SUMMARY REPORT

Re: Kolb Road: Connection to Sabino Canyon Road
Request for Feedback on Access Options

**Kolb Road: Connection to Sabino Canyon Road
Access Options Response Form Transcription**

Access Option #3

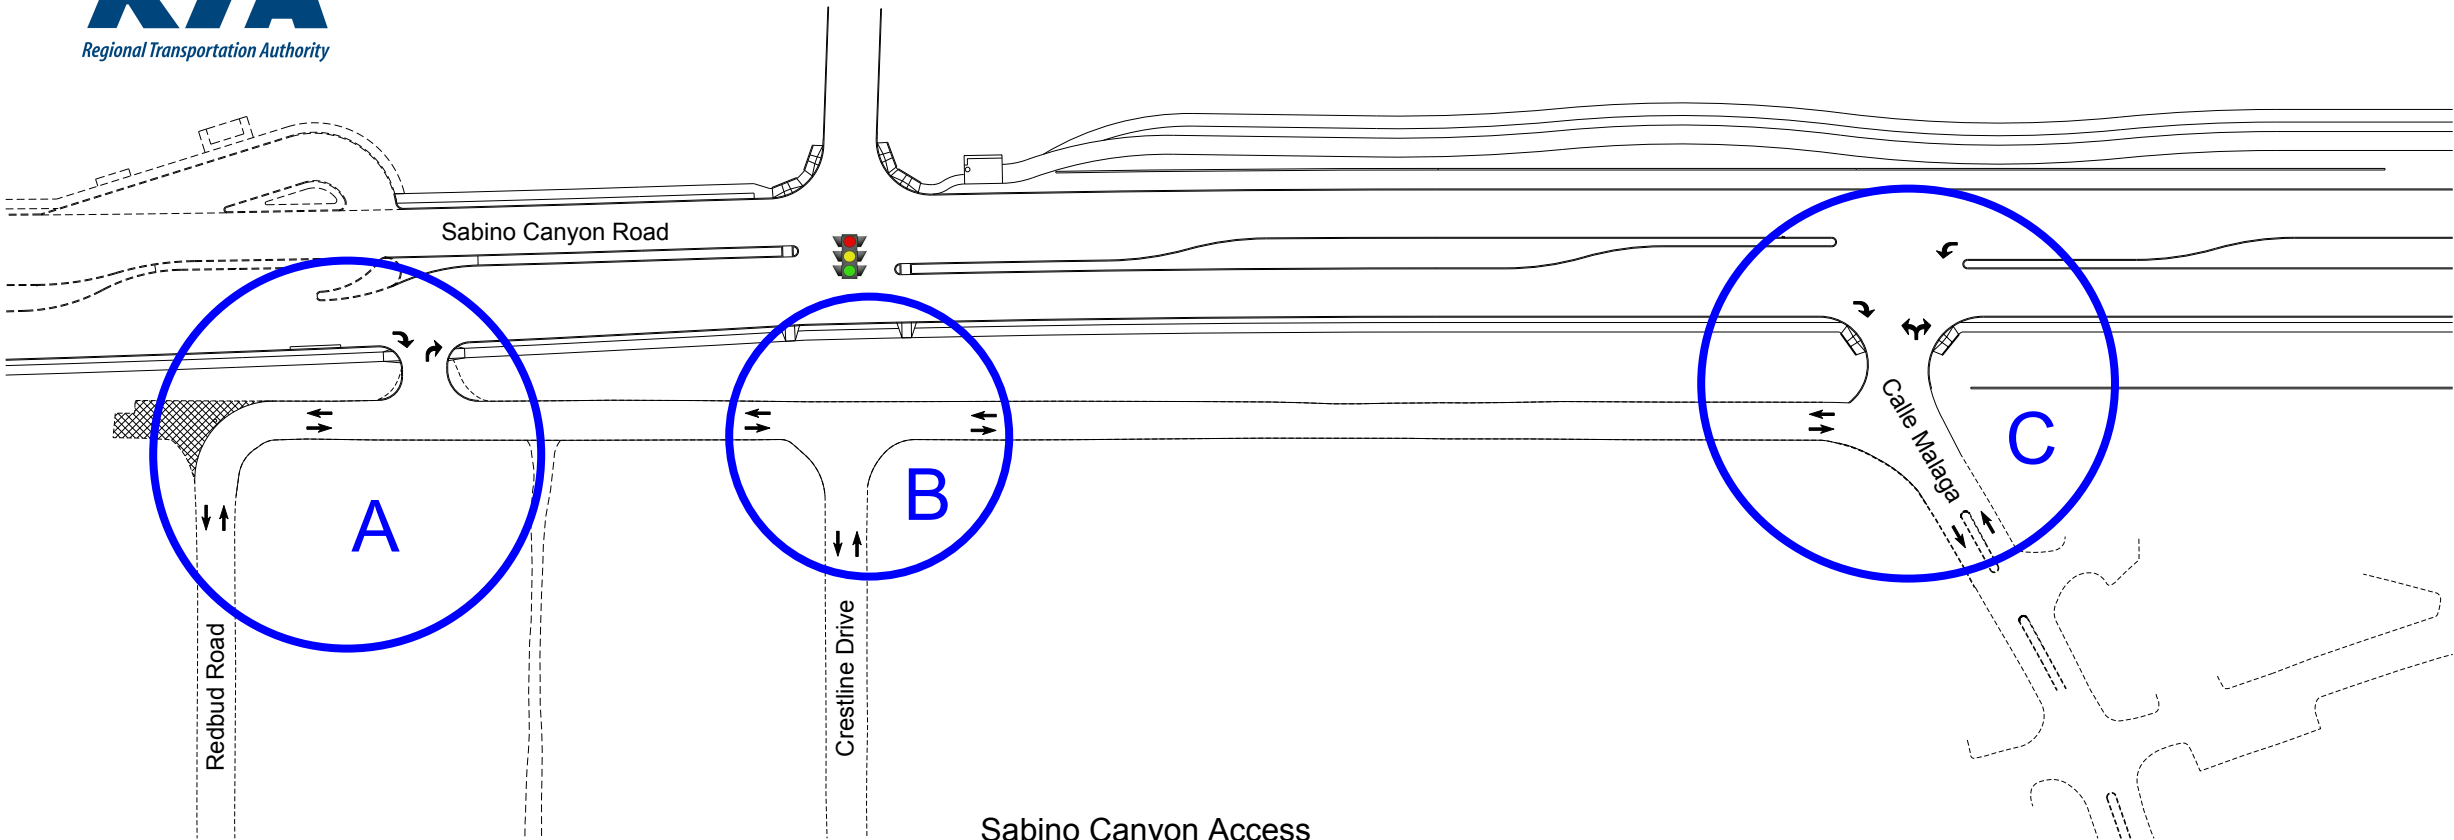
Comments
<p>OPTION #1 MOST – Ends at the end of each street make since to me. LEAST – Why can’t A + B meet at the signal?</p> <p>OPTION #2 MOST – Nothing LEAST – I think A + B access are too close, which would cause accidents. Dangerous.</p> <p>OPTION #3 Too much like option 2. I think it could be dangerous.</p> <p>GENERAL COMMENTS I think there are too many entries + exits which could cause car wrecks. I would have thought this was already cut + dried.</p>
<p>OPTION #1 MOST – All streets would have direct access. LEAST – Seems like it would encourage cut-through the most.</p> <p>OPTION #2 MOST – May discourage some cut through on Redbud, esp. with the dead end at the lighted intersection. LEAST – This may inadvertently flow more traffic down to Calle Malaga, which dead ends in Pantano II.</p> <p>OPTION #3 MOST – Appears to separate the neighborhood from heaviest traffic the best. LEAST – None of the intersections have access to the traffic signal – dangerous.</p> <p>GENERAL COMMENTS As a motorcycle rider who lives in Pantano II, direct access to the traffic light is a must for me from a safety standpoint. I do still see the potential for cut-throughs on Crestline, but I think some of that is unavoidable. The other big issues I can think of now is that there needs to be “dead end” or “no outlet” (or “local access only”) signage at or before the entrance to Pantano II > otherwise we’ll get people coming in the neighborhood & not being able to get out. We get this regularly already.</p>

Comments
<p>MOST – Best traffic pattern</p> <p>OPTION #3 MOST - Better than #1. Almost as good as #2.</p>
<p>OPTION #1 MOST – Only one way traffic on the side road/arterial in and out of Pantano II Townhomes (Calle Malaga) should reduce traffic noise.</p> <p>OPTION #2 MOST – See option 1 comments: and residents on Redbud won't have or shouldn't have the hassle of increased traffic on their street since they won't have a straight shot to Sabino Canyon so people may not be as inclined to use Redbud as a shortcut to avoid Tanque Verde/Sabino Canyon congestion.</p> <p>OPTION #3 LEAST – Don't like the two way traffic on the side road/arterial in and out of Pantano II (Calle Malaga)</p>
<p>OPTION #1 MOST – Most convenient easy access to all makes the most sense.</p> <p>OPTION #2 LEAST – Not convenient</p> <p>OPTION #3 LEAST – Not convenient</p>
<p>OPTION #1 Post signal no thru traffic > as below</p> <p>OPTION #2 Post a sign (no thru traffic)> at Sabino Canyon + Crestline and again at Tanque Verde + Indian School</p>

<p>OPTION #3</p> <p>MOST – Doesn't block access to Crestline's alley from its residents. Allow wider frontage road and more distance from the arterial roadway. Allows the neighborhood to maintain the current sense of community by keeping internal roadways connected rather than being separated by blocked frontage road and also by having two-way traffic on the frontage road. There is no drawback to this plan. OPTION #3 MOST (continued) Park will have ingress and egress without causing detrimental changes to the normal flow of Crestline and neighborhood traffic. Pedestrians can walk with the traffic light to the park and back.</p>
<p>GENERAL COMMENTS</p> <p>Please see attached sheet</p>
<p>ATTACHMENT</p> <p><u>With Regard to this Inquiry:</u> We formed a Neighborhood Association so that we would have more organization for matters of this type and because an association is granted more consideration than an individual would have.</p> <p>a. Why was this sent directly to all the homeowners in the area without first being sent to the association so the association could weigh in on what the options should be?</p> <p>b. Who decided that these three options are the only plausible ones?</p> <p>c. Also, by sending this with such a short turnaround, and during a time of summer vacations, many do not have a fair opportunity for voicing their choice anyway.</p> <p><u>Background:</u> Since the west entrance to Udall Park was opened, traffic has increased on Crestline Drive. It has also increased the speed on Crestline which is dangerous enough with curves, hill, cul-de-sac, alleys and a school bus stop in its less-than-three-block run. Non-Crestline drivers are exceeding the 25 mph limit and creating more danger.</p> <p>a. Park goers drove around the tiny island on the park road and down Crestline Drive to avoid the long wait at the intersection at Sabino and Tanque Verde.</p> <p>b. Pantano II residents also began using Crestline to leave the neighborhood rather than to wait at the signal at Sabino and Tanque Verde.</p> <p>c. Eventually, both groups also started using Crestline for ingress.</p>

<p>OPTION #1 LEAST – Full signalized access to Crestline!</p> <p>OPTION #2 LEAST – Full signalized access to Crestline!</p> <p>OPTION #3 MOST – <u>No</u> direct access to traffic signal to Crestline!</p> <p>GENERAL COMMENTS Please see attached!</p> <p>ATTACHMENT We would like to offer the following comments/information and request it be taken into consideration in making decisions concerning the proposed ingress/egress from Sabino Canyon Road into our neighborhood.</p> <p>First, we do not understand why a traffic light is necessary on Sabino Canyon at all. If the purpose of the Sabino Canyon/Kolb Road Extension is to improve traffic flow, why would a traffic signal be installed at all?? There is already a traffic signal at the North end of the park for cars to exit through. A pedestrian signal would be more efficient on Sabino Canyon for traffic flow and provide safety for pedestrians.</p> <p>The Redbud/Crestline neighborhood is very small in comparison with the number of residents in the Pantano II Townhomes. Therefore most of the traffic is from the Calle Malaga area and the connection at that point makes the most sense. Residence from Redbud and Crestline could also utilize the Calle Malaga ingress/egress.</p> <p>A better solution, would be <u>only</u> an opening from Sabino Canyon at Calle Malaga, and no openings from Redbud or Crestline. With both streets (Redbud & Crestline) closed at Sabino Canyon, the natural Mesquite Bosque that was removed could be replanted restoring some of the natural habit, help buffer some of the traffic noise from Sabino Canyon as well as noise from idling busses</p>

OPTION #3 MOST – Doesn't block access to Crestline's alley from its residents. Allow wider frontage road and more distance from the arterial roadway. Allows the neighborhood to maintain the current sense of community by keeping internal roadways connected rather than being separated by blocked frontage road and also by having two-way traffic on the frontage road. There is no drawback to this

<p>OPTION #1 LEAST – Makes Crestline & Redbud straight-aways through the neighborhood.</p> <p>OPTION #2 LEAST – Crestline is still a straight line through the neighborhood.</p> <p>OPTION #3 MOST – Keeps traffic out of the neighborhood & is the same entrance/exit as we currently have</p> <p>GENERAL COMMENTS Thank you for asking our opinion on this portion of the project.</p>
<p>OPTION #1 LEAST – Direct access to Redbud is not acceptable. 3 small children live # that intersection. The bus turns @ that location.</p> <p>GENERAL COMMENTS Thank you for this opportunity to modify the road plan Some of our residents may need more time to respond as/vacant home.</p>

Comments
<p>LEAST – Cars from Redbud would have to make a u turn at the lighting to go north – Very hazardous. Also DO NOT LIKE 2 way between Crestline/Calle Malago. Why drive traffic south with no light there!</p> <p>GENERAL COMMENTS</p> <p>Access Option #1 makes the most sense and reasonableness. I have been a Realtor in Tucson for 32 years and serve on the Board of Pantano II townhomes. There are 93 townhomes in Pantano II, whereas Redbud and Crestline <u>may have</u> only a few dozen homes that would need access. Therefore most cars would ingress/egress from Calle Malaga – Please do Access Option #1</p>
<p>OPTION #1</p> <p>MOST – Provides easy access for Rosebud + Crestline to Sabino Canyon Rd.</p> <p>OPTION #2</p> <p>LEAST – Limited access for Rosebud to Sabino Canyon Rd.</p> <p>OPTION #3</p> <p>LEAST – Limited direct access for Rosebud + Crestline to Sabino Canyon Rd – Could result in more traffic going south to Indian Ruins – + to Camino Principal in order to get to a signal.</p>

Access Option #4

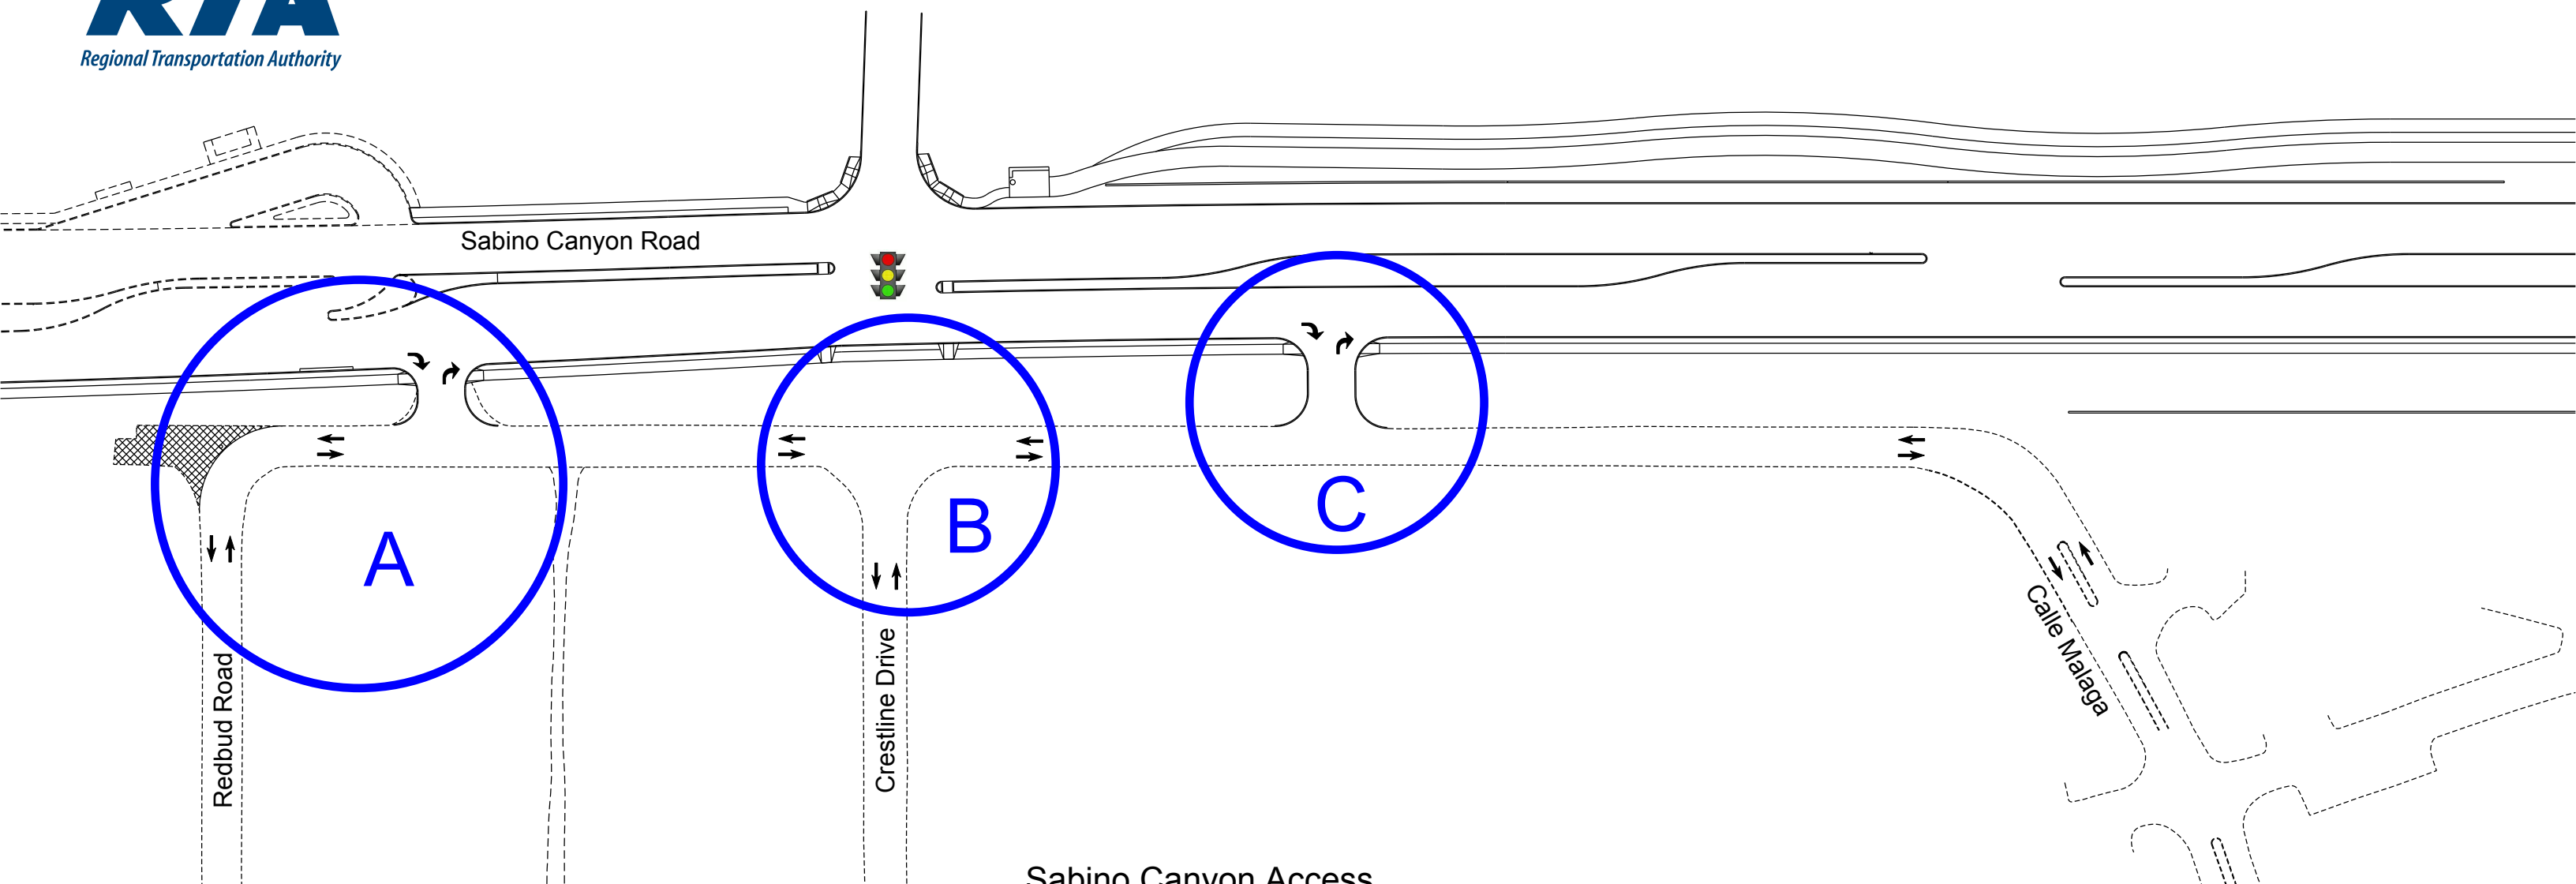
NOTE: Tucson Fire Department has indicated that this option is **not acceptable**.
